Three Mile Island Nuclear Station, Unit 2 (TMI-2)
Operating License No. DPR-73
Docket No. 50-320
Defueling Canister Technical Evaluation Report

Attached are responses to your comments on the Defueling Canister Technical Evaluation Report (TER) transmitted by your letter dated June 10, 1985. Based on these responses, GPU Nuclear will submit a revision to the Defueling Canister TER.

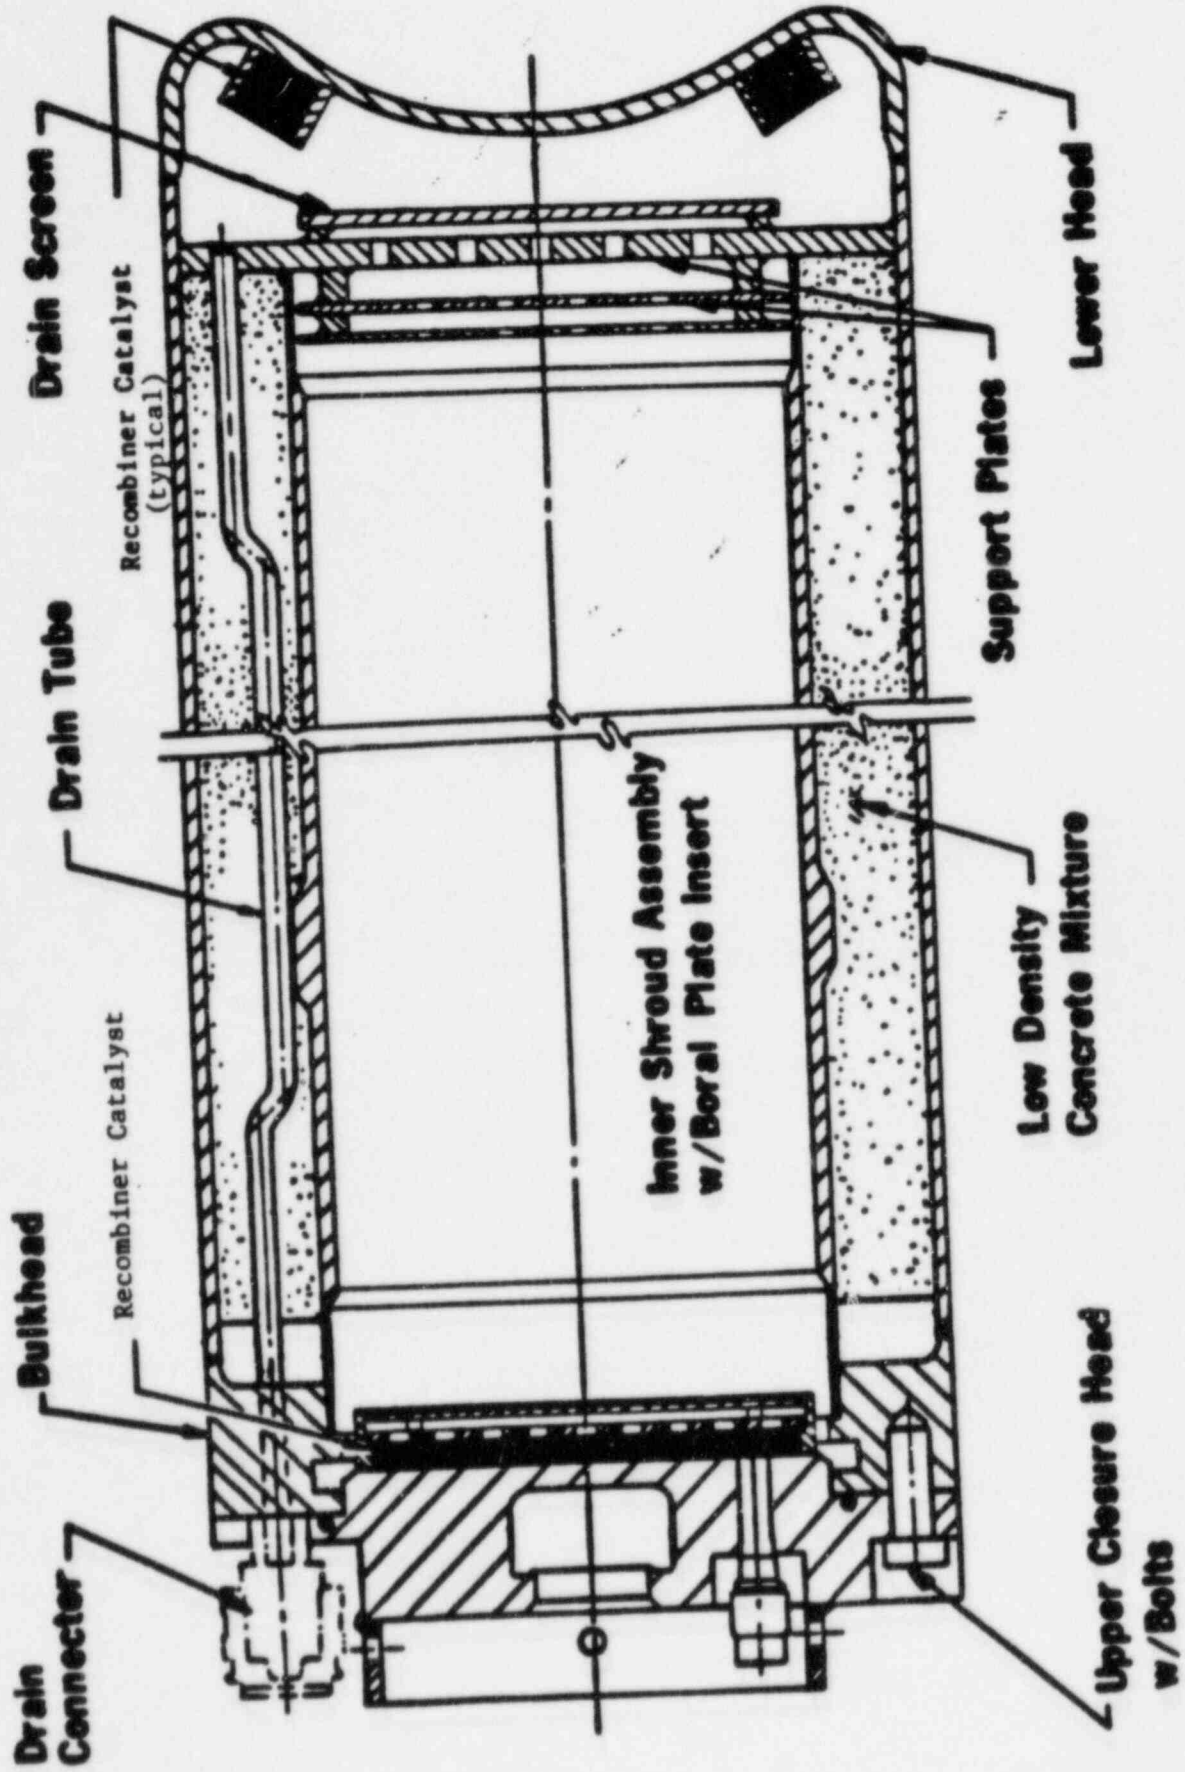
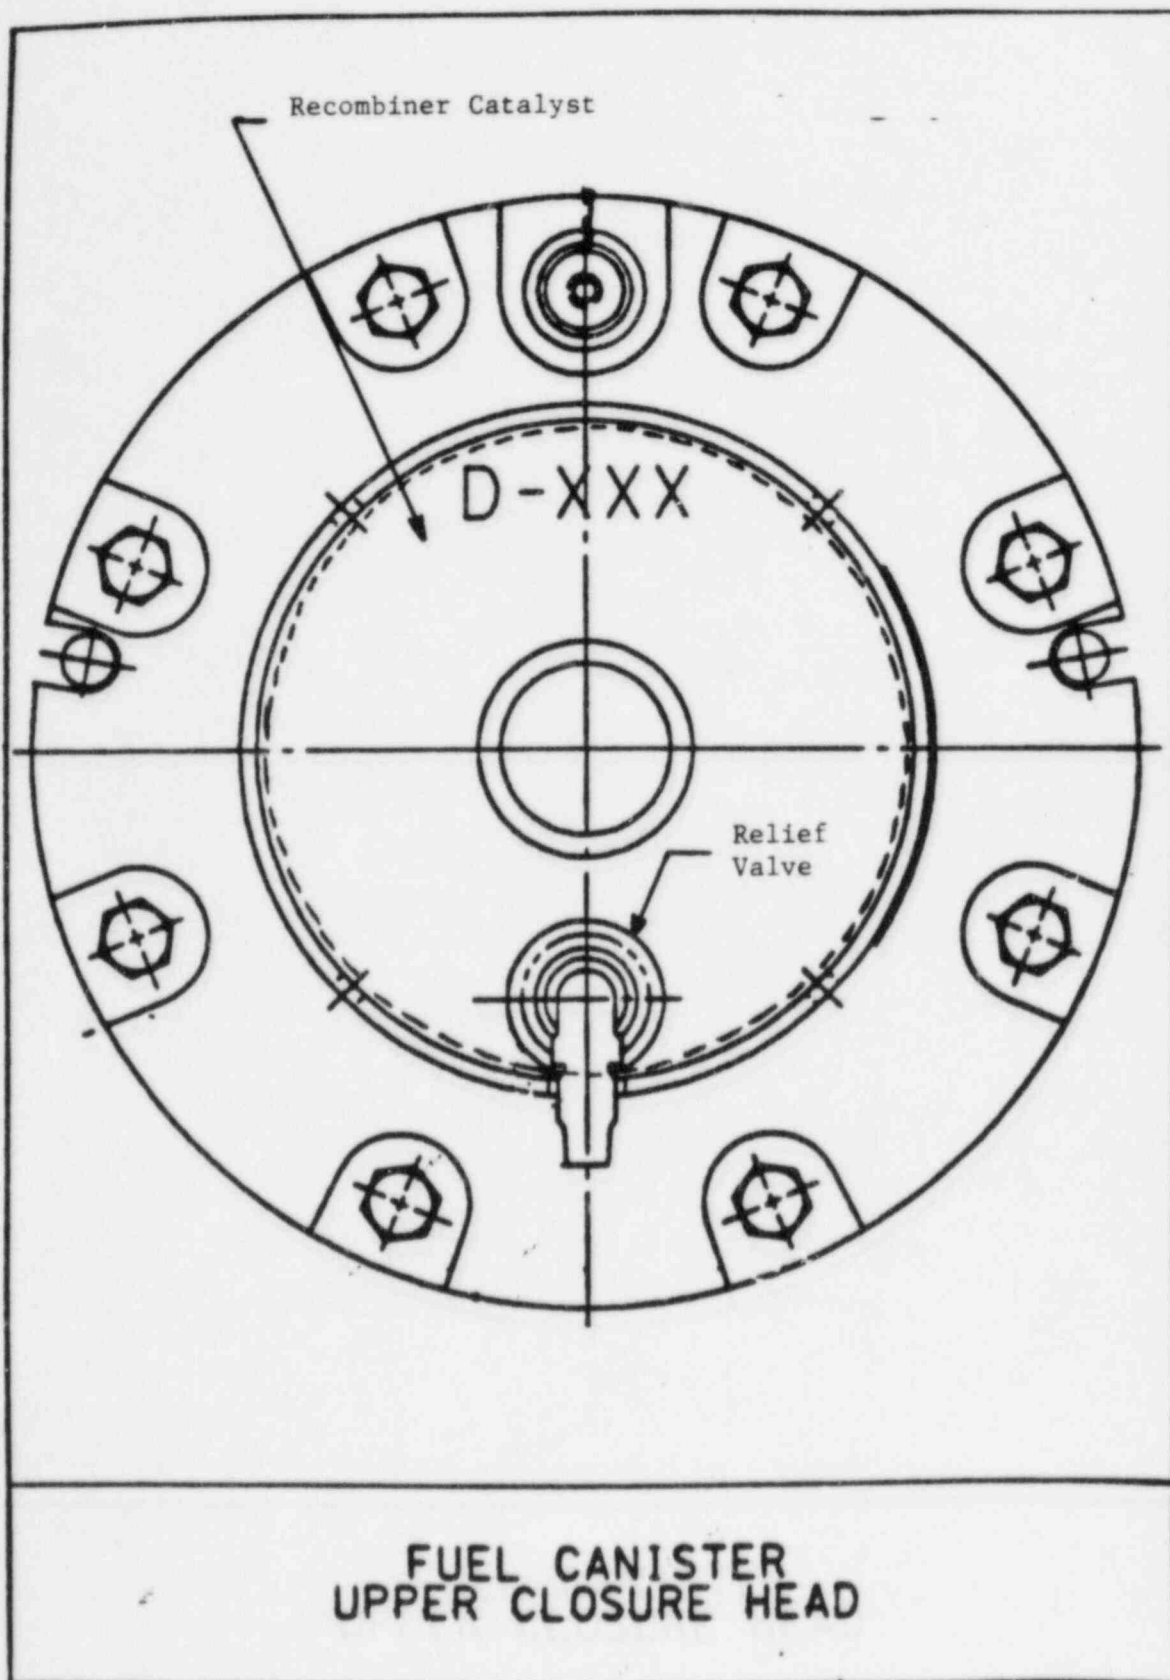
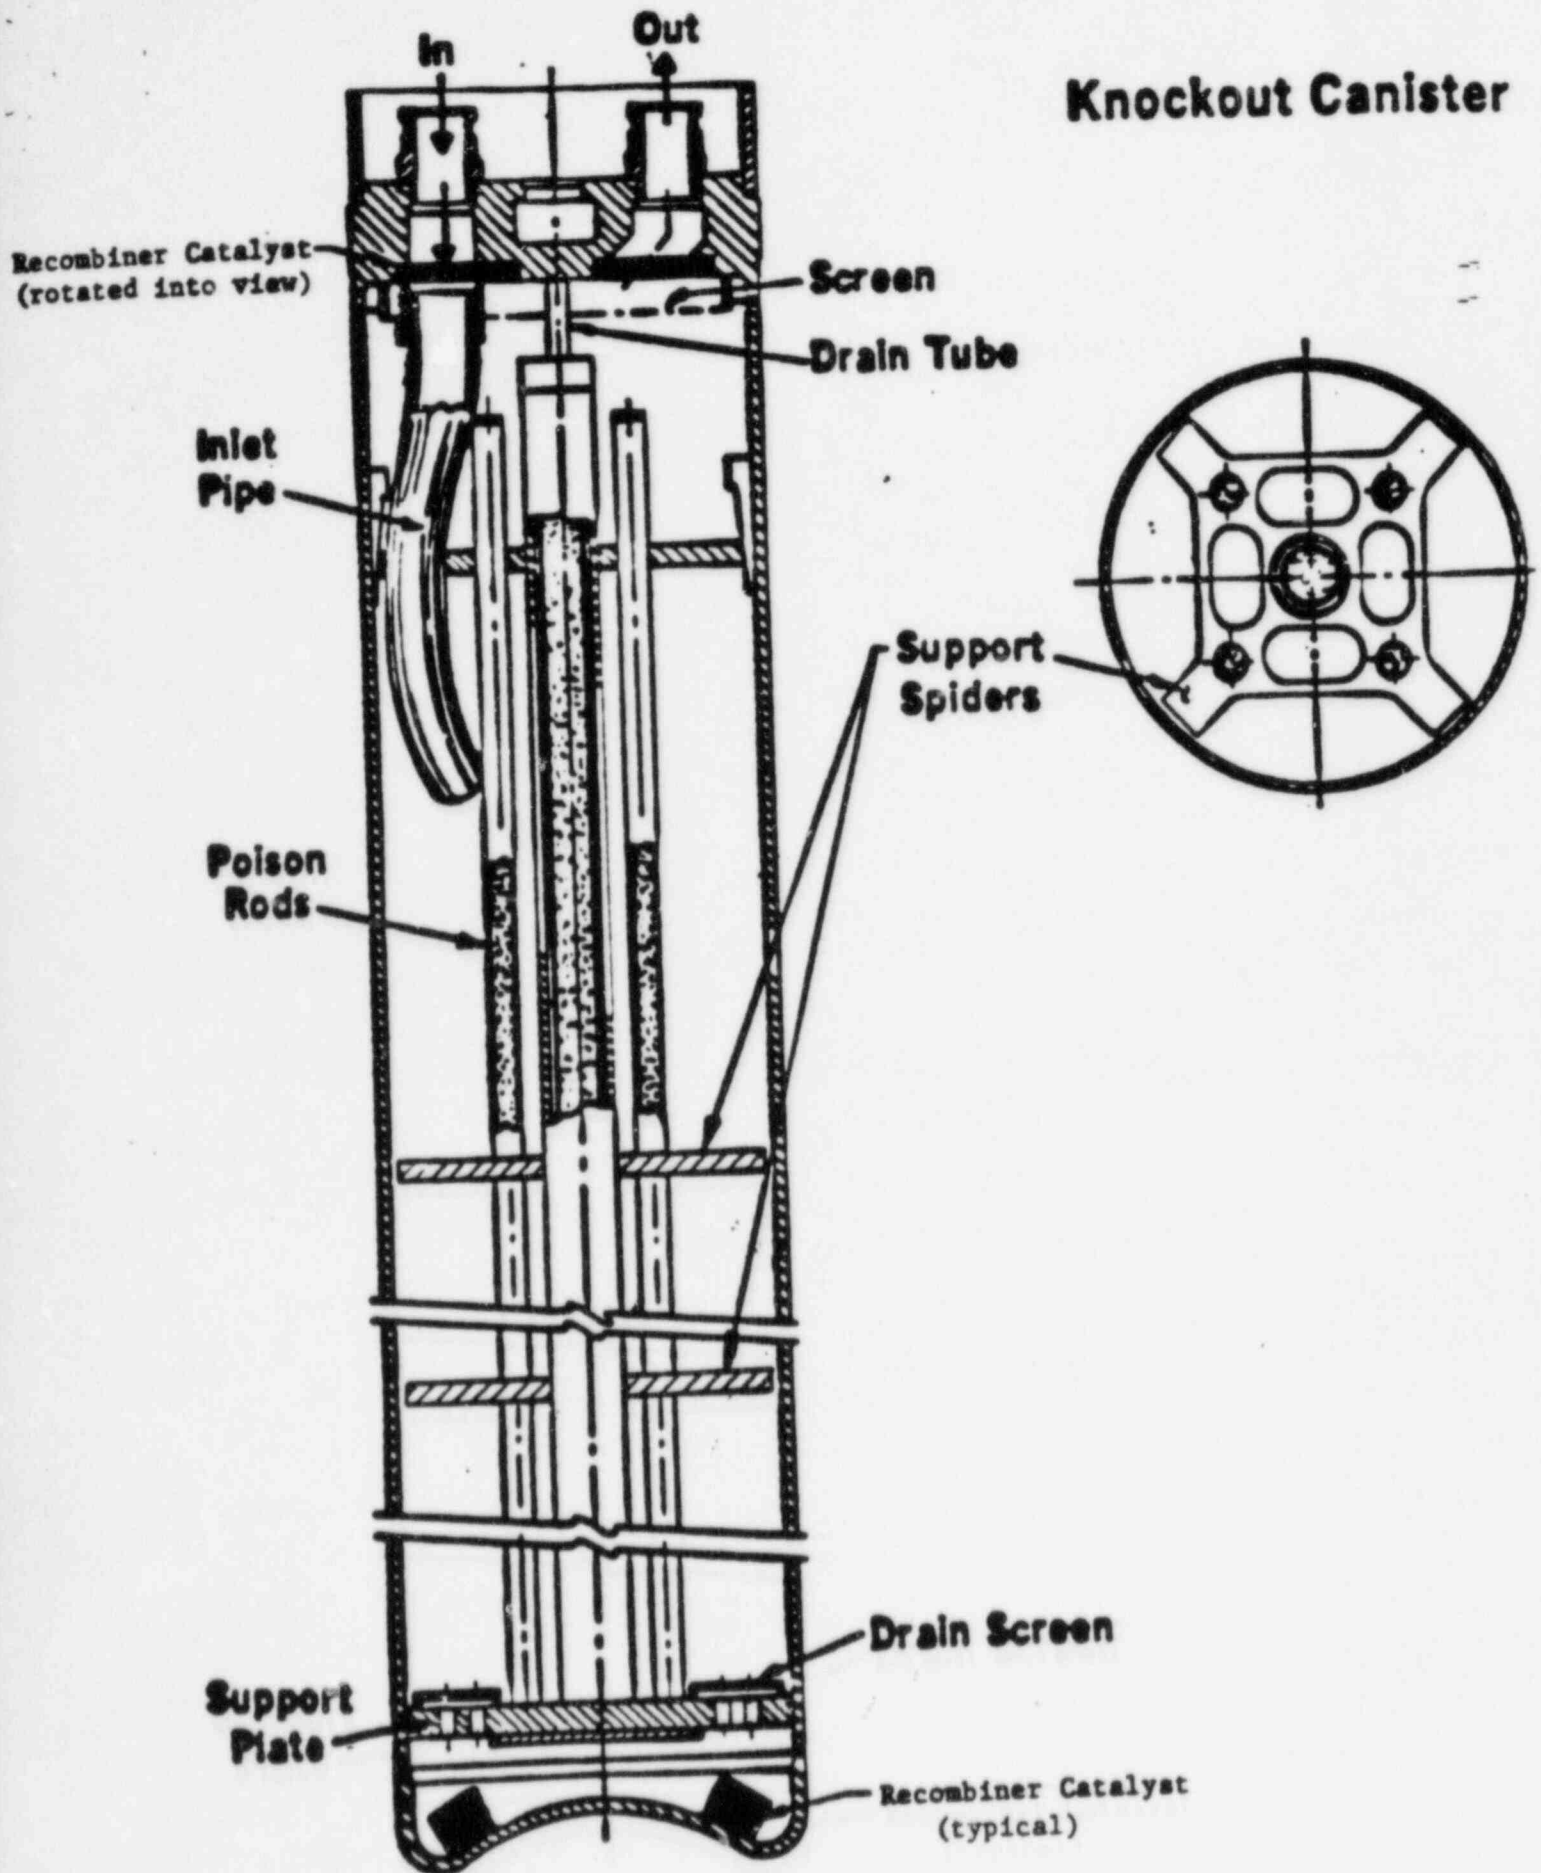
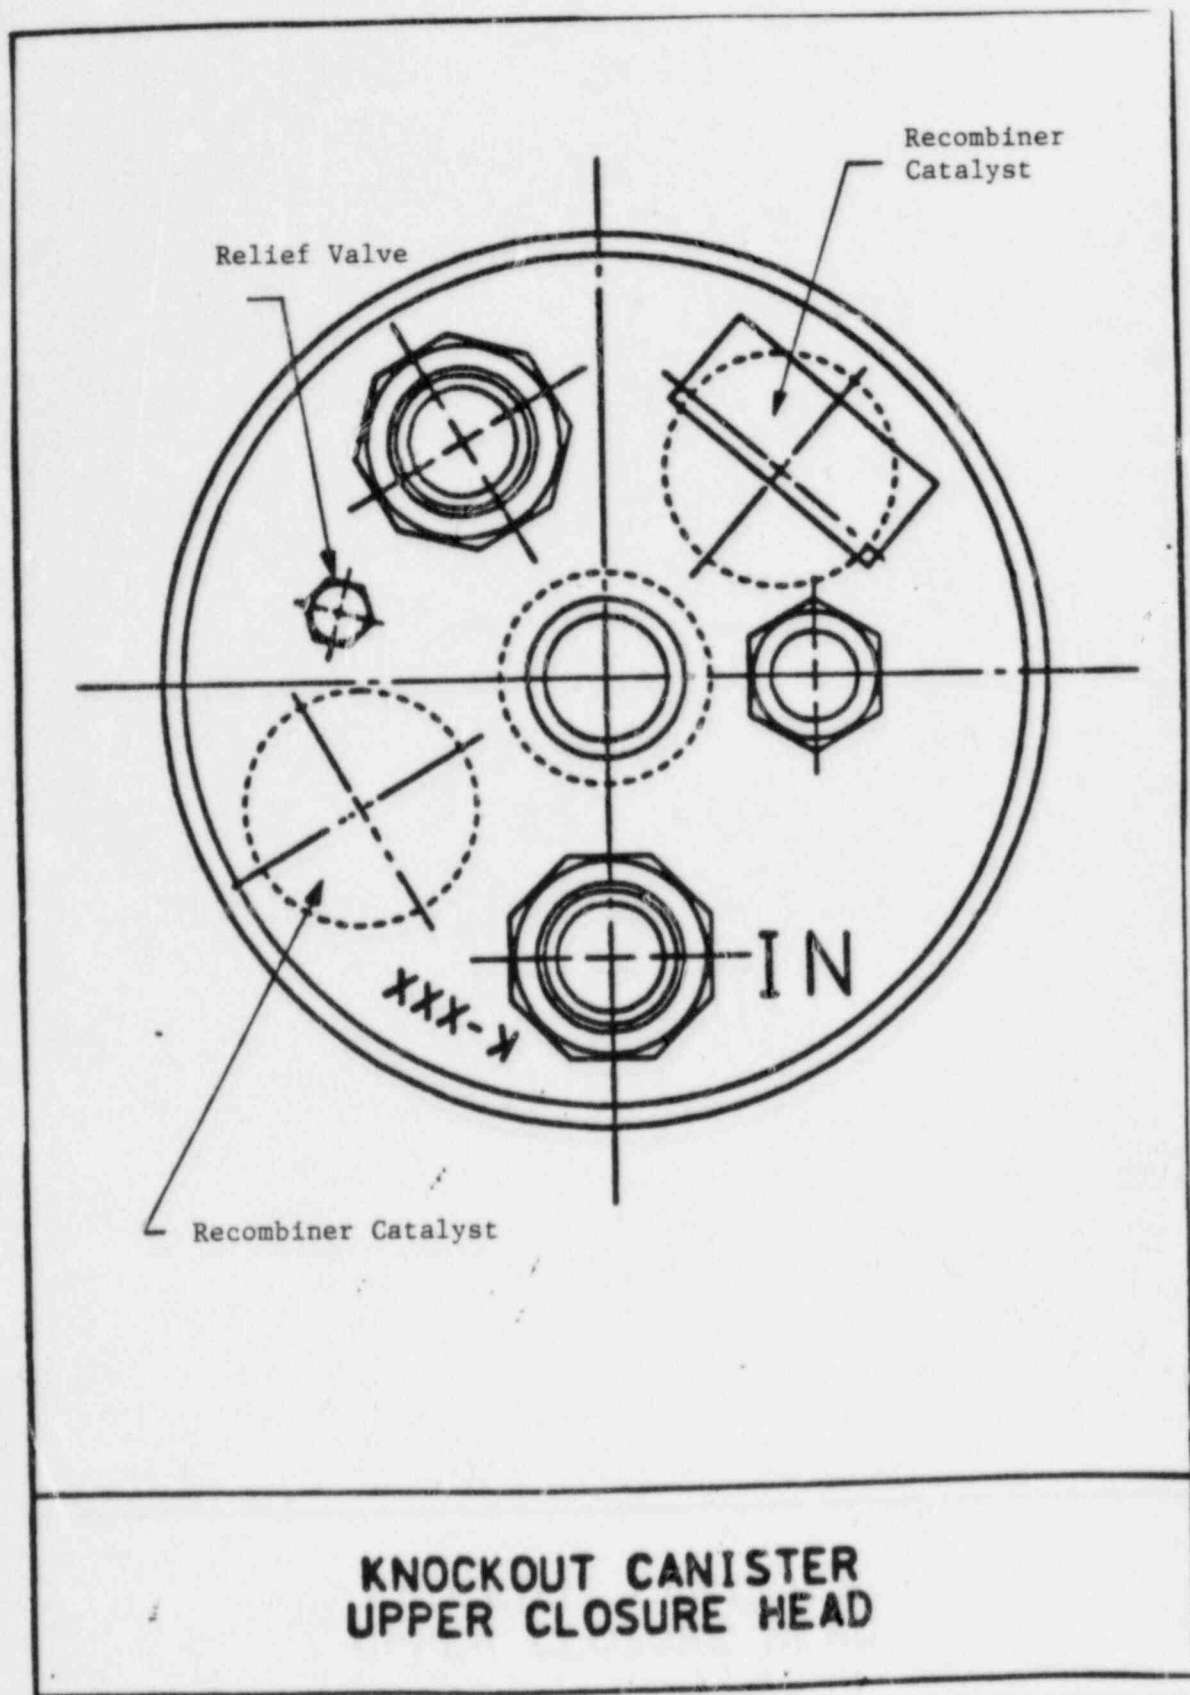
Question 9: Explain the basis for your assumption that the first or second opening of the relief valve will expel enough water to expose the recombiner catalyst.

Response: The catalyst beds are located at the extreme ends of the canisters. Since the canisters will be operated vertically, evolved gases will migrate to the top of the canisters and the catalyst beds. See attached sketches.
